PREMIER BUILDING SUPPLY OF KANSAS CITY 20300 W 207TH St Spring Hill, KS 66083 Phone: 913.686.1812 www.premierbuildingsupply.com Clayton Properties Wildflower - Transitional 3 Car 1612 SW Buckthorn St. HR Lot 161 Kyle Clifford Designer: Michael Dueker 5/22/2024 | P240463 | NTS ROOF TRUSS PLACEMENT

SHOP DRAWING / SUBMITTAL

DIAGRAM

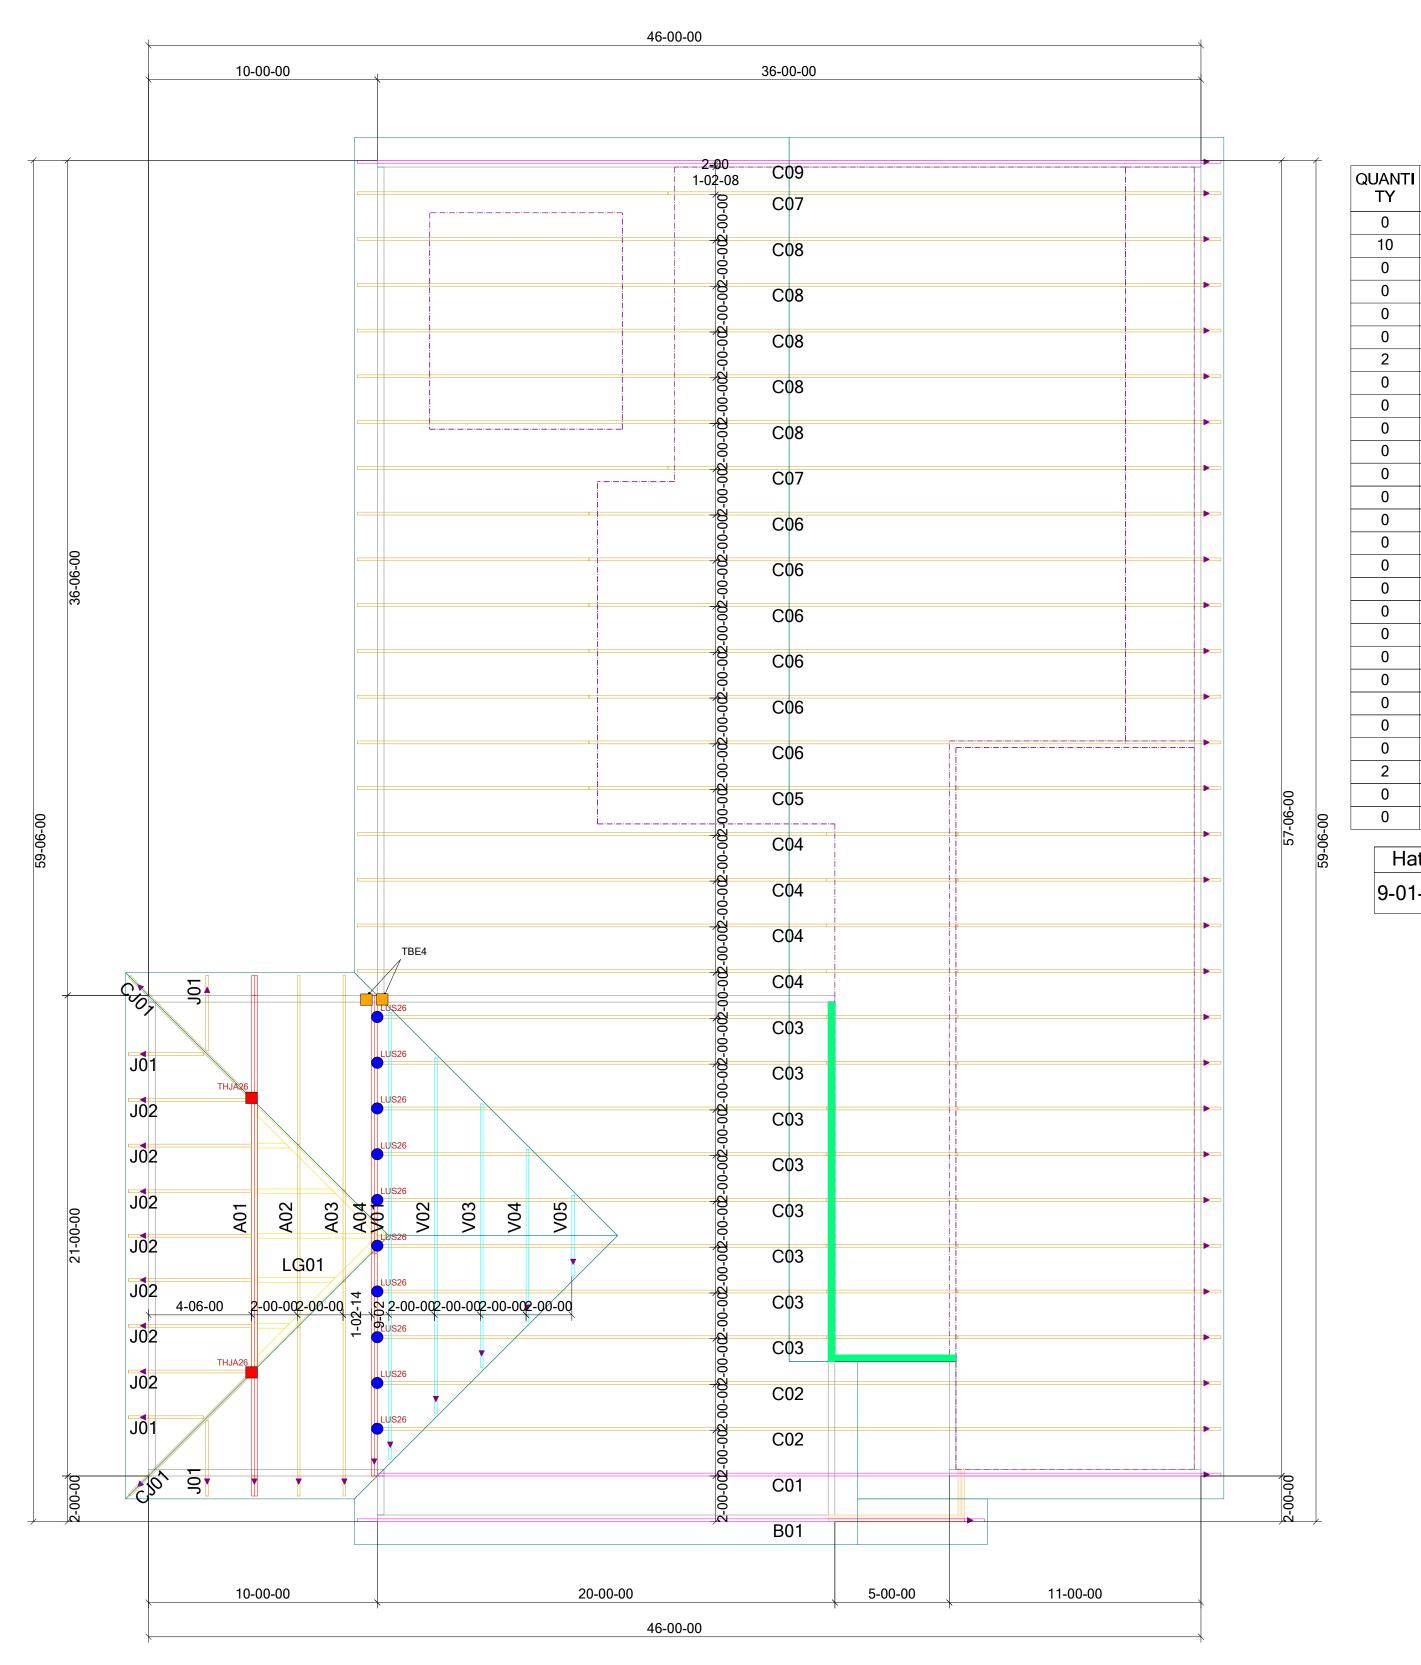
> **APPROVED** 06/05/2024
